REVISION A Supercedes previous versions  
July 19,2013 Updated to latest software numbers

**TITLE: ACM PROGRAMMING & RELAY ADDITION**  
Prevost vehicles

On the vehicles affected by this bulletin, a relay needs to be added to allow the DEF to return to the tank after turning the key to the OFF position. In addition, the ACM & MCM need to be reprogrammed to the latest version.

## FROM – TO LIST:

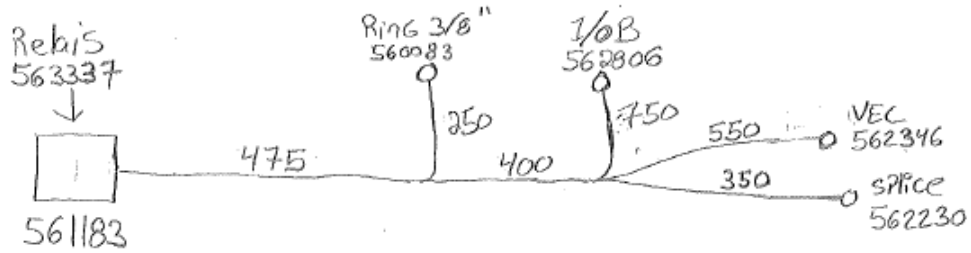
3. Add a relay (R49) in rear electrical compartment in the indicated location. Refer to images below.
4. Prepare patch harness according to best practices for harness & wire protection. If required refer to standard 10.4a available in BMS (<http://bms.buses.volvo.net/>).
5. Connect per instructions.
6. Re-program MCM to the latest version with VPG Prevost Vehicle Program Generator.

| H series |        |                |        |        |            |             |      |        |
|----------|--------|----------------|--------|--------|------------|-------------|------|--------|
| Wire     | From   | To             | End1   | End2   | Length(mm) | Length (in) | Gage | Color  |
| 24VD8C   | R49:30 | VECR 10:E      | 561181 | 562346 | 1425       | 56.1        | 12   | Red    |
| 24VD8    | R49:87 | splice:24VD8   | 561181 | 563624 | 1225       | 48.2        | 12   | red    |
| 425      | R49:86 | A51, J1:20     | 561181 | 562806 | 1625       | 64.0        | 16   | orange |
| 00B      | R49:85 | ELECTRONIC gnd | 561181 | 560083 | 725        | 28.5        | 16   | black  |

### H-SERIES for ref only.

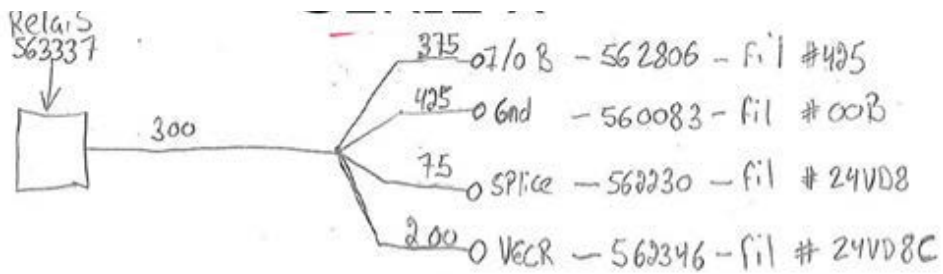
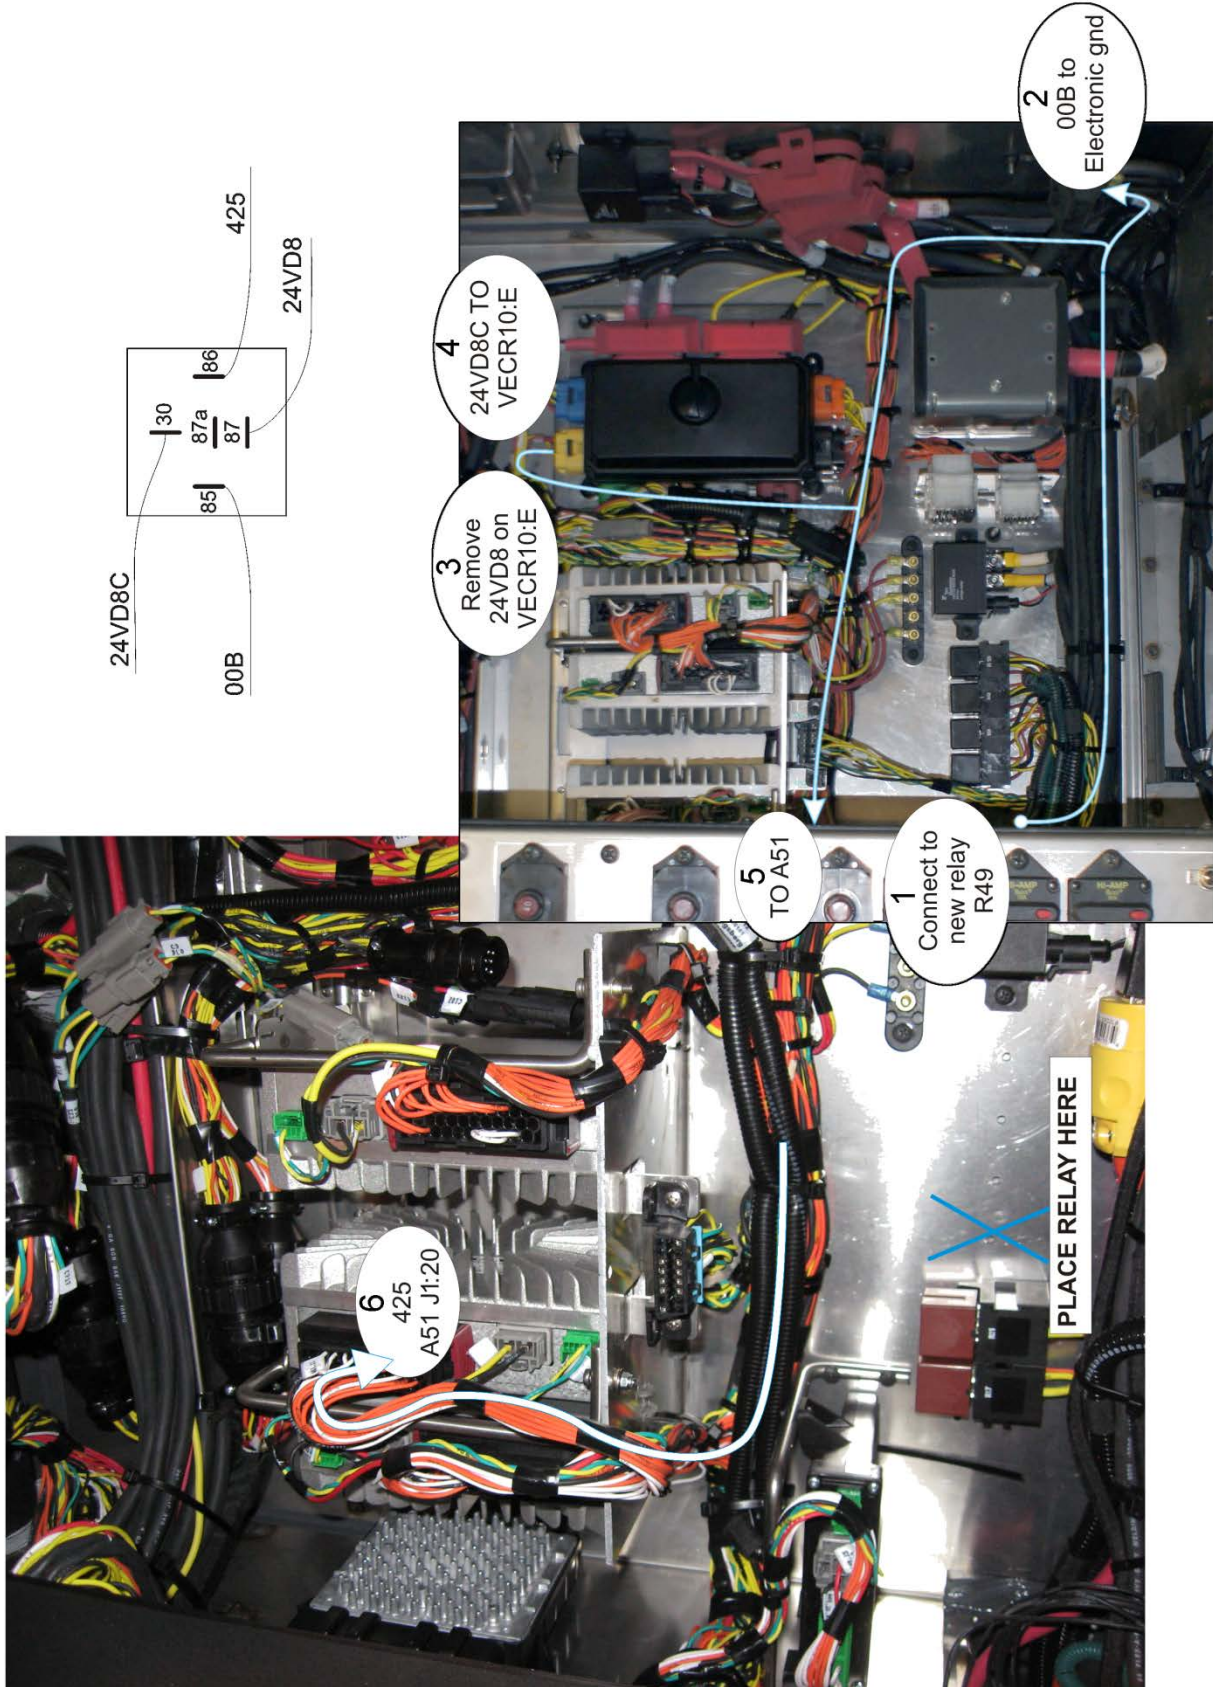
1. Connect patch harness to relay
2. Connect wire 00B to electronic ground post
3. Remove 24VD8 on VECR10:E and splice to new 24VD8 wire
4. Connect wire 24VD8C to VECR 10:E
5. Route wire 425 towards A51
6. Connect wire 425 to A51:J1:20
